Access Compliance Report

Public Rights-of-Way

(Curb Ramps)

Intersection ID: 44785	Main Street: KINGS_PARADE_BV	Cross Street: VENDOME_ST	Location: NE
ADA ID: A66AD6F145CE	Ramp Type: Directional1	Initial Pass/Fail: Fail	Overall Compliance: No
Severity Score: 1.25			
Codes/Mitigation Info/Possible Solution		Field Measurements/Component Compliance

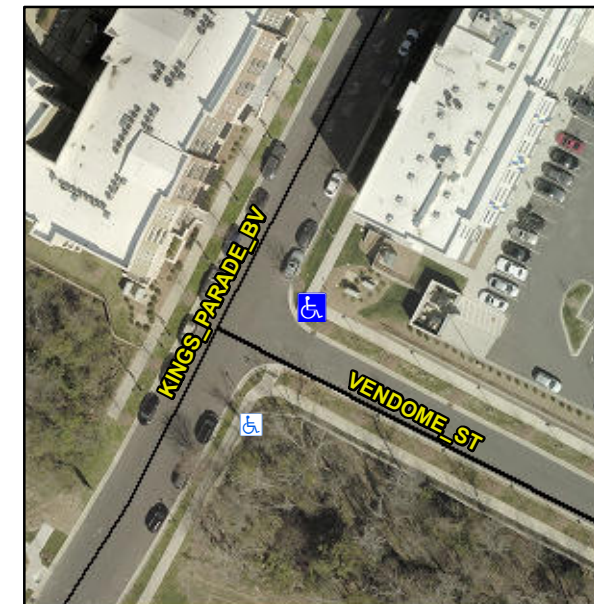
Compliance	Description	Data	Compliance	Description	Data
N/A	Ramp Length (in)	78.0	N/A	Grade Break?	N/A
Yes	Ramp Width (in)	72.0	N/A	Grade Break Slope (%)	0.0
Yes	Ramp Slope (%)	3.5	N/A	Grade Break XSlope (%)	0.0
No	Ramp XSlope (%)	3.3			
N/A	Flare Type LT	N/A	N/A	Flare Type RT	N/A
N/A	Flare Slope LT (%)	N/A	N/A	Flare Slope RT (%)	0.0
N/A	Flare Traversable LT?	N/A	N/A	Flare Traversable RT?	N/A
N/A	Landing Length (in)	0.0	N/A	DWS Provided?	N/A
N/A	Landing Width (in)	0.0	N/A	DWS Contrast?	N/A
N/A	Landing Slope (%)	0.0	N/A	DWS Length (in)	N/A
N/A	Landing X Slope (%)	0.0	N/A	DWS Full Width?	N/A
N/A	Landing Curb? (Y/N)	N/A	N/A	DWS Offset LT (in)	N/A
N/A	Shared Landing?	N/A	N/A	DWS Offset RT (in)	N/A
N/A	Gutter Ponding?	0.0	N/A	Gutter Slope (%)	N/A
N/A	Gutter Lip Ht (in)	0.0	N/A	Gutter X Slope (%)	N/A
N/A	Painted X Walk1?	No		Road Slope (%)	1.1
	X Walk 1 Direction	To SW		Road X Slope (%)	1.4
	X Walk 1 Width (in)	N/A		Clear Space?	N/A

Remove & Replace Entire Ramp.

R304.5.3
